# SERVICE LETTER SL44 66-12107 Rev A

**66-12107 SPACER, FWD FUSELAGE FITTING, AEROCET MODEL 6650 FLOAT INSTALLATION, KODIAK AIRCRAFT**

66-12107 ISOMETRIC VIEW

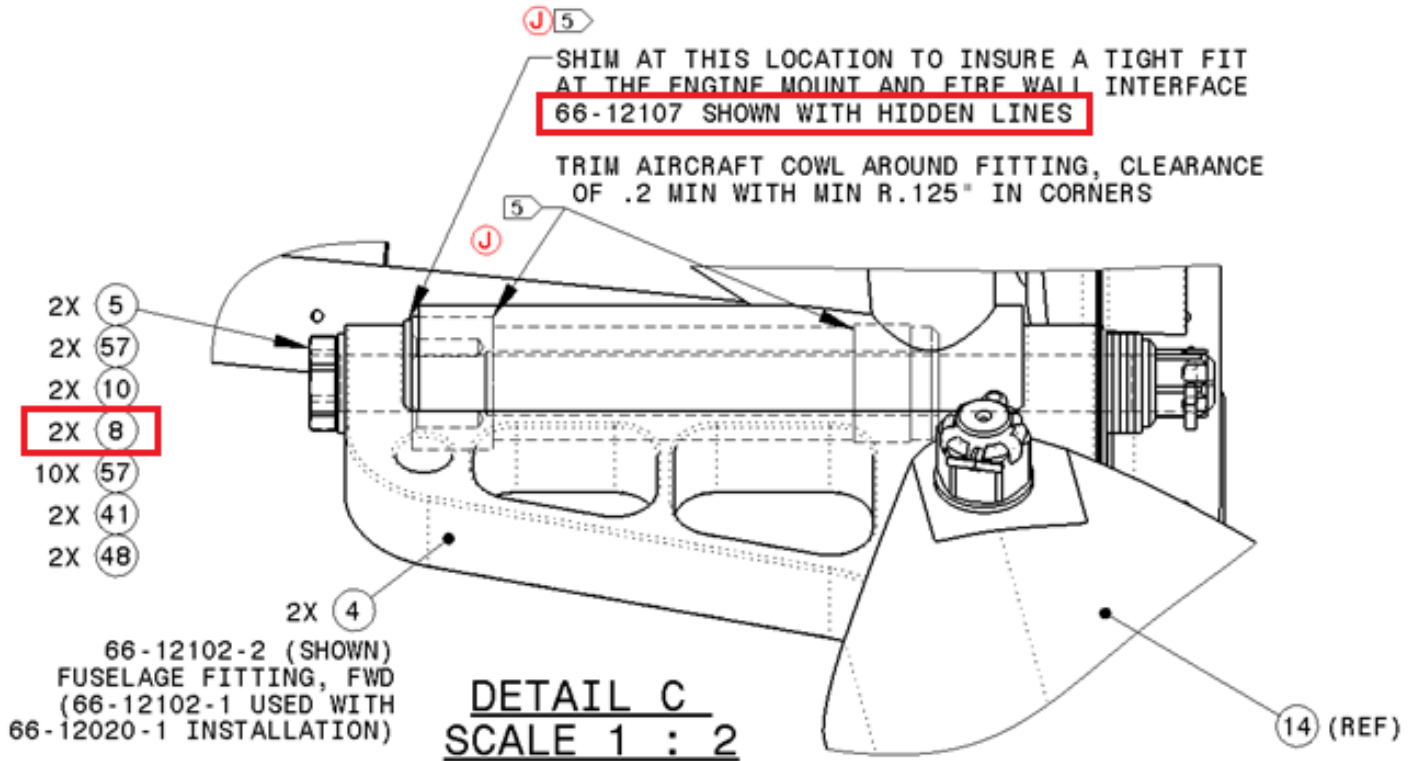
To accommodate the tolerance of the engine mount, Aerocet redesigned the 66-12107 spacer, ultimately manufacturing them in three different outside dimension sizes. The -1 is the smaller of the spacers and the -3 is the largest.

Existing parts in the field that were previously installed can still be used *as long as they do not conflict with the engine mounts and pass a visual inspection for excessive wear and damage.*

The installer or mechanic is to use the largest dash number (66-12107-1 through -3) that will fit inside the engine mounts.
